# **SOUND PRINCIPLES AND AN IMPORTANT INCONSISTENCY IN THE 2012 UK BIOENERGY STRATEGY**

**Tim Searchinger**  
**Woodrow Wilson School of Public and International Affairs,**  
**Princeton University ([tsearchi@princeton.edu](mailto:tsearchi@princeton.edu))**  
**(September 20, 2012)**

**Figure 4: Carbon sequestered and emissions avoided (saved, compared to a reference scenario) by harvesting UK conifer forests and using the wood in different applications to displace non-wood products and fossil fuels**

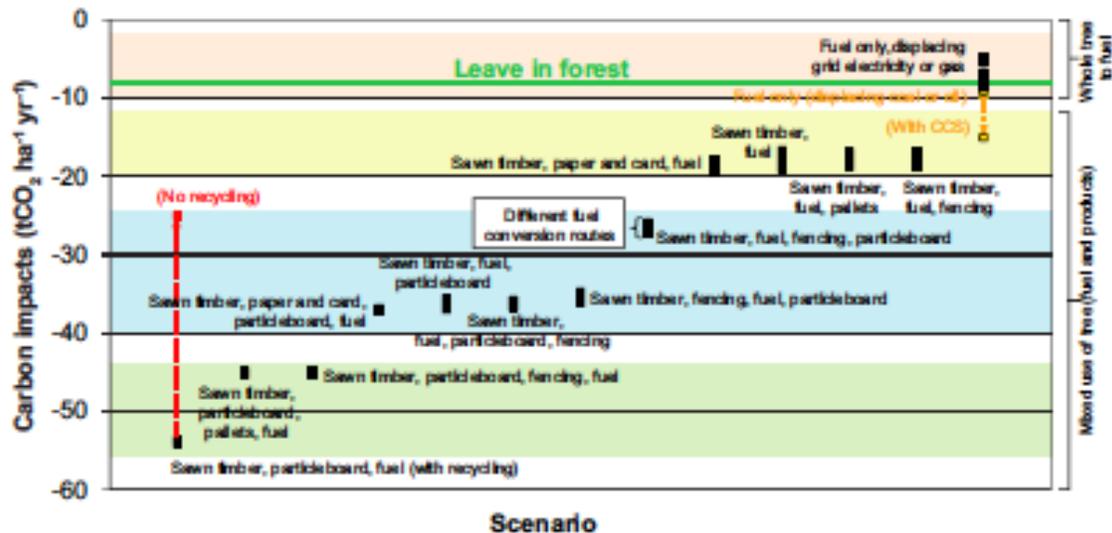
Figure 4 shows savings per hectare not savings per kilowatt-hour compared to the use of coal. Fortunately, DECC has since provided the underlying data behind this figure for the harvest of wood from conifer trees to replace coal for electricity. Conifer trees are among the fastest growing tree species, and therefore produce the best greenhouse gas results. I show the calculations in Appendix A and I have confirmed these calculations with DECC. In short, the DECC analysis assumes that electricity from coal generates 1,042 gCO<sub>2</sub>/KWh, and estimates that replacing coal with conifer wood results in:

- a 14% GHG reduction over 100 years (902 g/KWh)
- a 49% increase over 40 years (1557 g/KWh)
- an 80% increase over 20 years (1879 g/KWh)

Although Figure 4 and the accompanying text are ultimately clear, elements of the presentation could result in some misunderstandings.

First, Figure 4 presents a large number of fuel alternatives under the title of “carbon impacts of harvested wood,” and most of them look highly favorable. A casual reader might mistakenly assume favorable results from the harvest of wood generally for bioenergy. Yet, all of these favorable alternatives involve using wood first for various products and then burning the wood for energy only after their useful product lives. Such biomass is conventionally viewed as a form of waste because it must be collected when products are thrown away or demolished. Such uses will reduce greenhouse gas emissions.

Second, the presentation of results in Figure 4 based on a 100-year time horizon obscures the large increases in emissions estimated over several decades. That discussion is incompatible with the Strategy’s explicit principle that bioenergy must contribute to the UK’s 2050 greenhouse gas goals. As the UK has announced goals for reducing greenhouse gas emissions by 80% by 2050, uses of bioenergy that increase emissions over such time periods obviously help to meet these goals. I also note that these kinds of goal are implicit in the commitment to trying to hold global temperature increases anywhere near 2 degrees C, which requires large cumulative carbon reductions between now and 2050.<sup>4</sup>

**Box 14: Carbon cost effectiveness of non-waste biomass in power (new build dedicated plants and conversions/co-firing)**

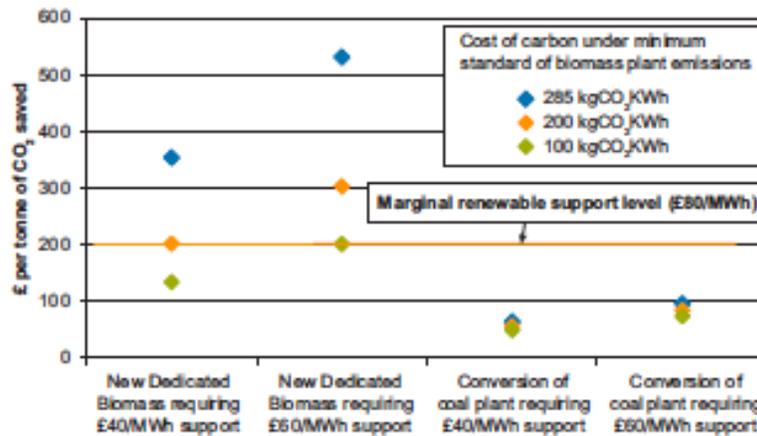
In turn, Box 14, reproduced here, analyses the costs of carbon abatement using "non-waste biomass" at three different possible emissions levels for biomass: 00, 200 and 285 gCO<sub>2</sub>/kWh. With coal emissions estimated at 909 kgCO<sub>2</sub>/KWh, the result is cost-effective mitigation. (Note that Box 14 has a typographical error, identifying emissions in one place at kilograms of CO<sub>2</sub> both per "KWh" and in another at kilograms per "MWh." The correct units for the figures cited should be kg/MWh or g/KWh.)

How then can we make sense of Box 14? Put another way, how can Box 14 assume bioenergy emissions of 100-285 g/KWh even though Figure 4 uses an estimate for whole trees of 902 g/KWh even over 100 years? The explanation is simple. The illustrative range of emissions in Box 14 from 100 to 285 gCO<sub>2</sub>/KWh represent estimates of emissions solely from the production of the biomass, and they exclude emissions that result from the change in forest carbon. In other words, they represent emissions from the fossil energy used to grow, harvest, process and transport the biomass, not from the decrease in forest carbon stocks, foregone carbon sequestration or from land clearing. (Nor do the numbers include emissions from the diversion of timber from other uses that help hold down emissions, which is implicitly shown in Figure 4 as well.)

*In summary, the emissions estimates used by DECC to establish that biomass electricity offers a cost-effective means of reducing emissions from power are based on a methodology for lifecycle analysis that Principle One of DECC's strategy rejects outright and corrects on pages 29-31.<sup>6</sup> Effectively,*

although Box 14 claims to judge use of “non-waste” biomass to be cost-effective, that judgment properly applies to the use of waste biomass.
